NEW RESIDENCE AT 40 SUNRISE ROAD, PALM BEACH STATEMENT OF ENVIRONMENTAL EFFECTS ADDENDUM

This addendum to the Statement of Environmental Effect is being provided for DA2021/0900 at 40 Sunrise Road, Palm Beach, to assess environmental impacts of the modifications prepared in response to comments provided by council (letter dated 15/09/21)

Above; 3D representation of the proposed building form relative to the 10m building height line (red) demonstrating the entire form remains below the height plane

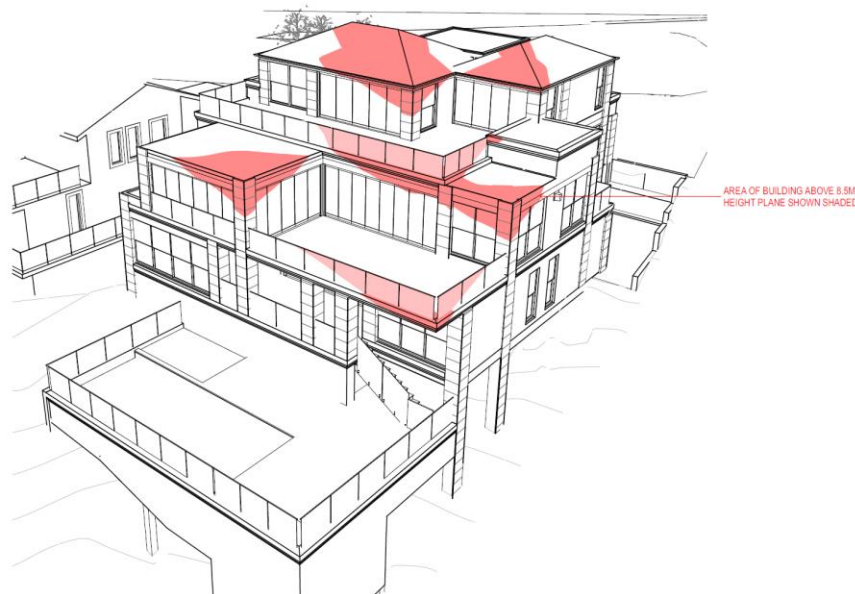
The proposed building FFL's have been lowered to allow the proposal to better follow the existing site topography, prevent the building from exceeding the 10m height plane, and minimize the density of the building exceeding the 8.5m building line. As a result, the proposal now achieves a maximum height of 9.95 (1.65m reduction compared to original proposal) with the area of mass above the 8.5m line considered minor in nature, given that the masses do not obstruct neighbouring views, or generate overshadowing over the neighbour's principle living spaces. The lowering of the building's height closer to existing ground levels minimizes the dwelling's visual density and reinforces the surrounding landscape as the dominant feature.

Above; 3D representation of the proposed building form identifying the parts of the form which exceed the side envelope plane, and areas of volume deleted from the original proposal

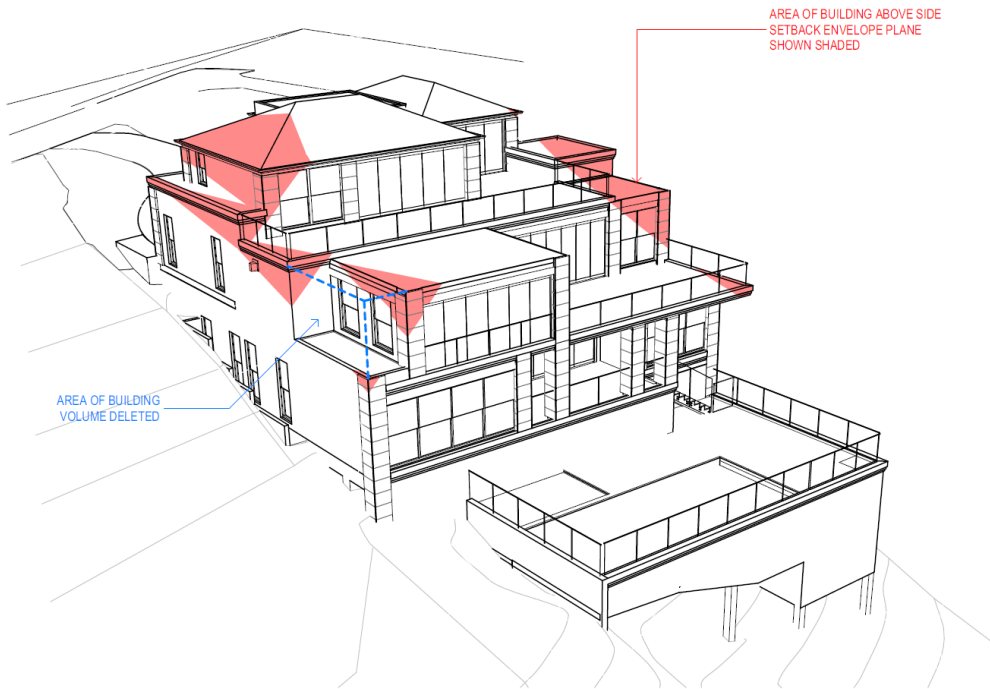
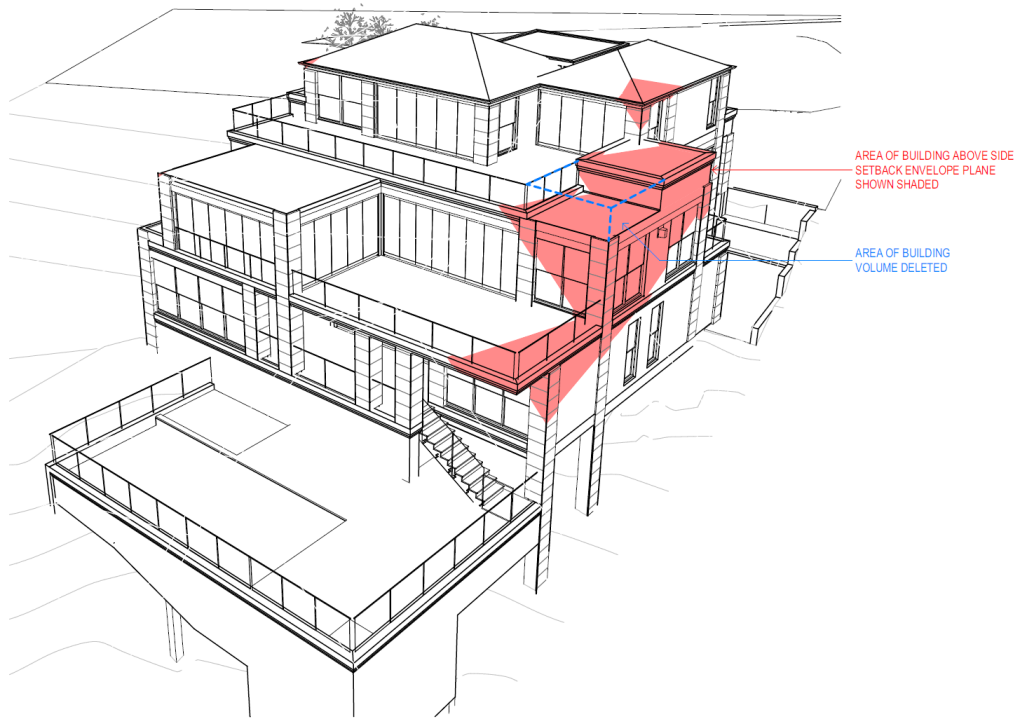
It is noted that council particularly had concerns regarding the breach of the side building envelope control. Though the proposed modifications still exceed the control due to the sites steep slope, by lowering the dwelling's height an additional 0.9m, the volume which breaches the plane has been significantly reduced. The larger contributing masses, such as the eastern façade of the Dining Room, and the planter box along the western façade over the Living room, have also been removed to further minimize the dwelling's mass. Given that the areas of the dwelling that exceed the envelope do not impact on the visual or solar amenity of the neighbour's, and no longer exceeds the 10m height plane, the variation from the standard is considered reasonable, and in keeping with the objectives of the control.

FIG 1 Above; Demonstrating the proposal's compliance with the average building height of the adjoining properties

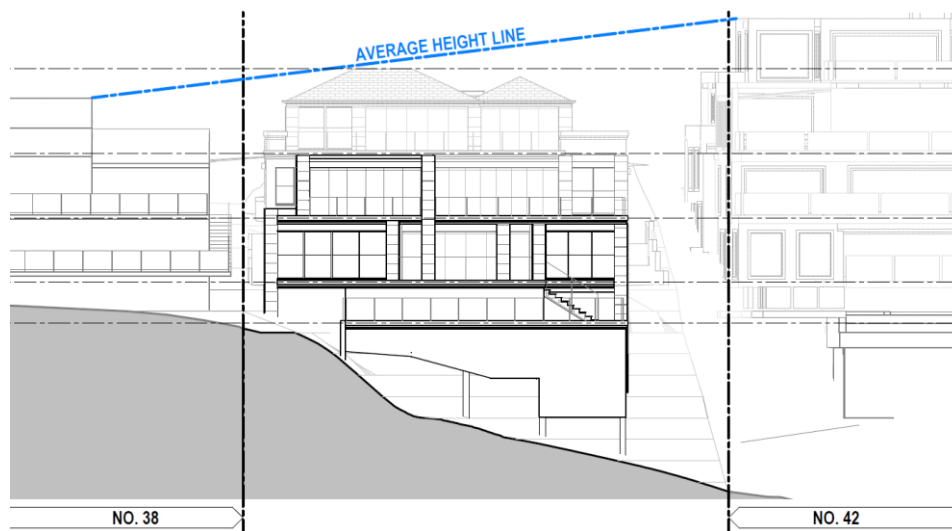
b) to ensure that buildings are compatible with the height and scale of surrounding and nearby development,	The height of the proposal is consistent with the average height line established between the adjacent dwellings No. 38 and No. 42, as demonstrated in Fig. 1	YES
